## **Technical Service Information**

## THM 4L60 (440-T4) REVISED ACCUMULATOR ASSEMBLY

## Figure 1

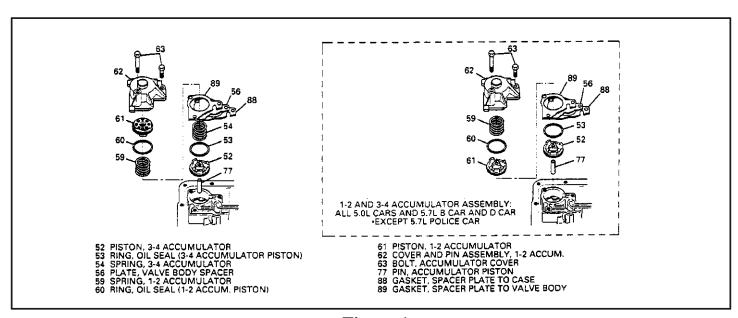
Beginning with the Start of Production for 1993, <u>SOME MODELS</u> of the THM 4L60 (700-RA) transmissions were built with a new calibration that eliminates the 3-4 accumulator spring, and <u>INVERTS</u> the 1-2 accumulator piston and spring (See Figure 1).
